September 17, 2015 – ITEM

North Central Texas Council of Governments

SUBJECT: Resolution Endorsing the 2015 International Codes and Regional Code Amendments

RESOLUTION ENDORSING THE 2015 INTERNATIONAL CODES AND REGIONAL CODE AMENDMENTS

****Figure R602.6.1; delete the figure and insert the following figure:**

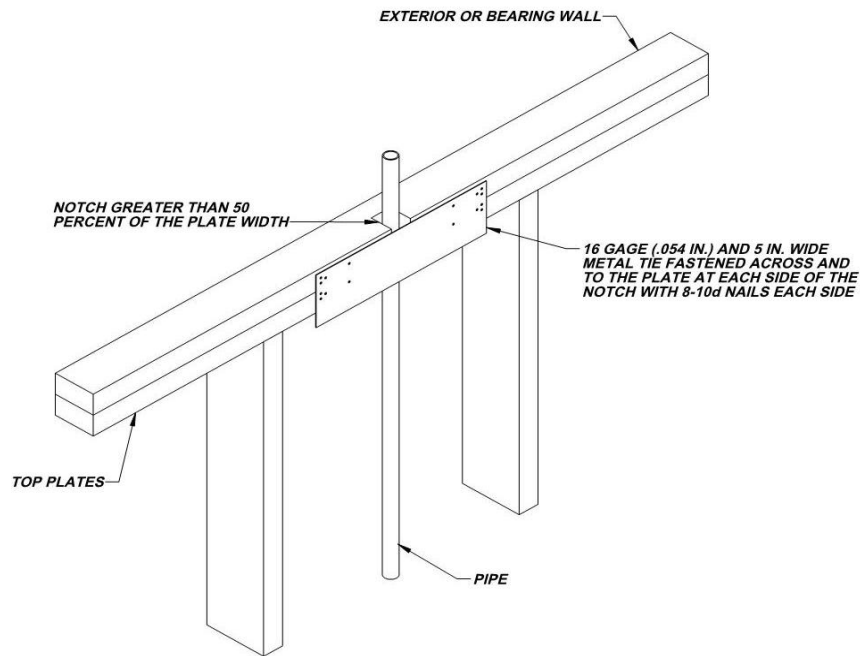
R602.6.1 Drilling and notching of top plate. When piping or ductwork is placed in or partly in an exterior wall or interior load-bearing wall, necessitating cutting, drilling or notching of the top plate by more than 50 percent of its width, a galvanized metal tie not less than 0.054 inch thick (1.37 mm) (16 Ga) and ~~4 ½ inches (38 mm)~~ 5 inches (127 mm) wide shall be fastened across and to the plate at each side of the opening with not less than eight 10d (0.148 inch diameter) having a minimum length of 1 ½ inches (38 mm) at each side or equivalent. Fasteners will be offset to prevent splitting of the top plate material. The metal tie must extend a minimum of 6 inches past the opening. See figure R602.6.1. {remainder unchanged}

(Amendment to 2012 IRC carried forward to 2015 IRC also provides additional assurance of maintaining the integrity of the framing by spreading the nailing pattern.)
